**ADDENDUM NUMBER:** \_\_\_\_\_

**MUNSON ROAD SWITCHGEAR REPLACEMENT  
16 MUNSON ROAD  
FARMINGTON, CT 06032**

UCONN PROJECT NO. 14-601.07

**DATE: September 27, 2019**

**PARTIAL THIRD FLOOR PLAN**

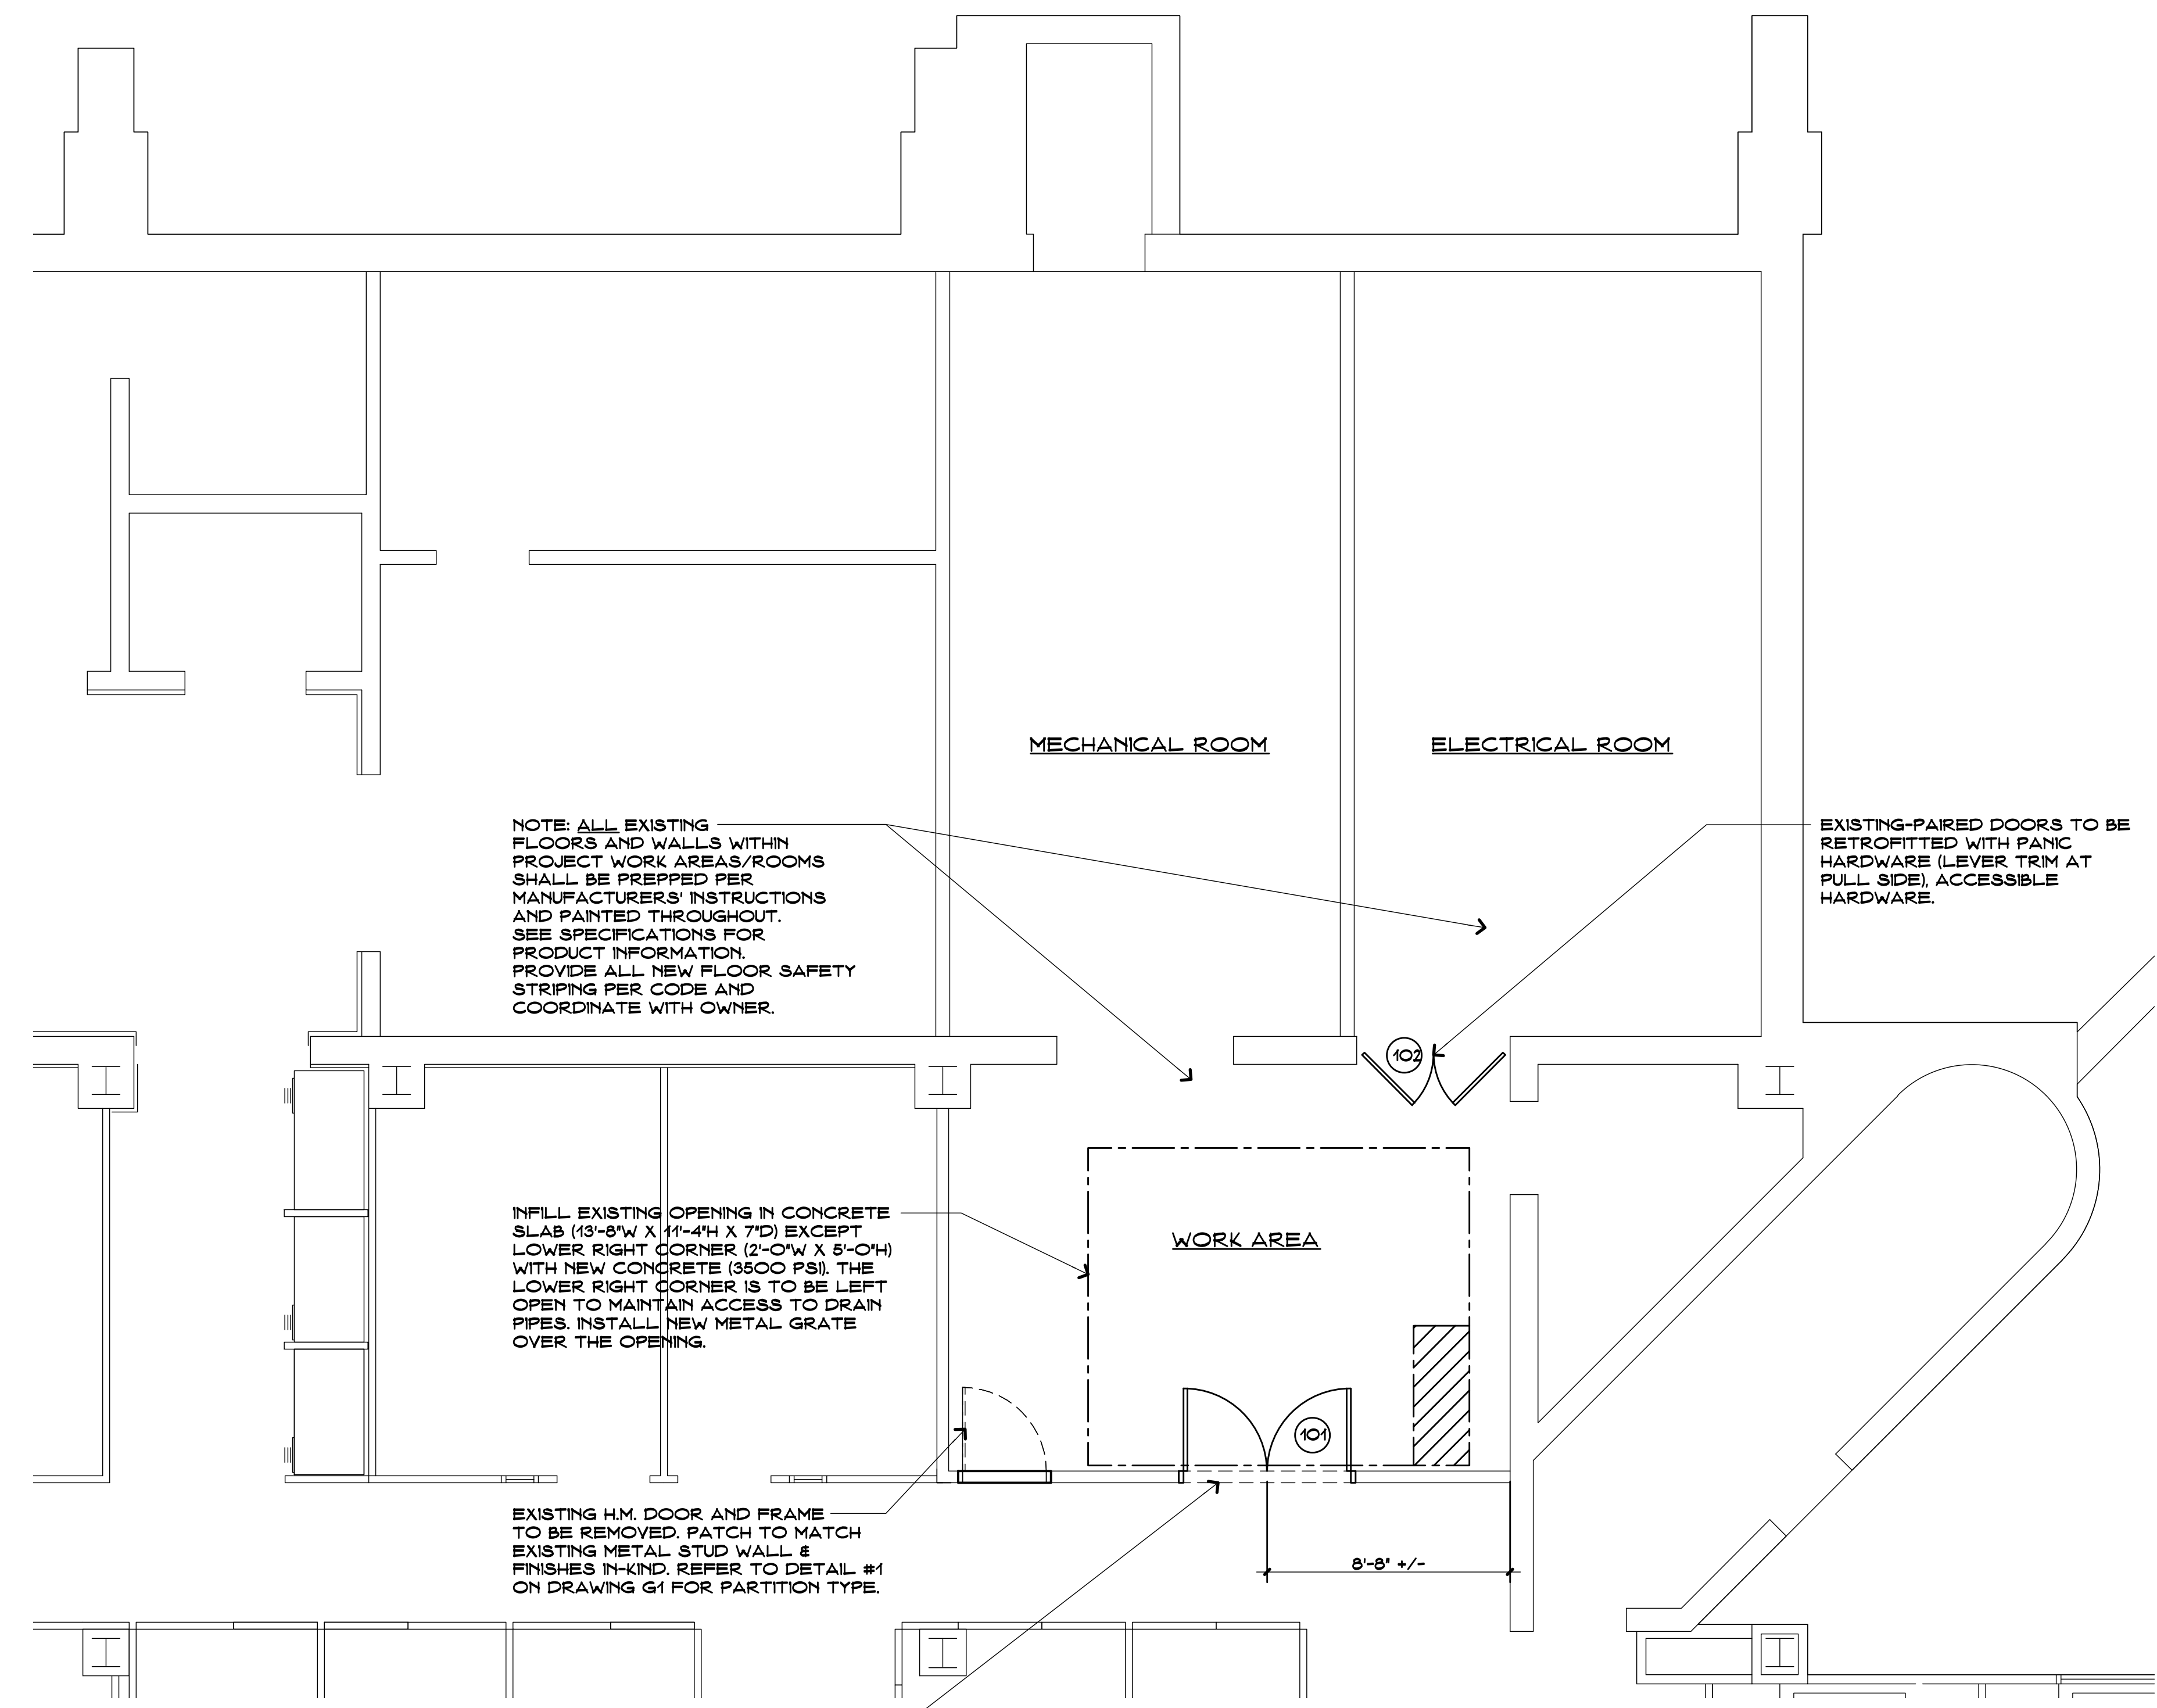
- **DELETE:** The following Drawings in their entirety:
  - Cover Sheet.
  - A1 “Architectural Plan”
  - E3 “Electrical Plan”
  - E5 “One-Line Diagram”

- **ADD:** The following Revised Drawings, dated September 25, 2019:
  - Cover Sheet.
  - A1 “Architectural Plan”
  - E3 “Electrical Plan”
  - E5 “One-Line Diagram”

DOOR		FRAME		FIRE		HARDWARE - SEE PROJECT MANUAL		REMARKS
DOOR NUMBER	SIZE	TYPE	MATERIAL	DETAIL/SHEET NO.	RATING	FIRE CODE	DISABLED REQUIREMENTS	
101	3'-0" X 8'-0"	HM	HM	A	1			PROVIDE AUTO FLUSH BOLTS, DR COORDINATOR
102	3'-0" X 8'-0"	HM	HM	A/A1	1			PROVIDE NEW PANIC HARDWARE/LEVER AT PULLSIDE
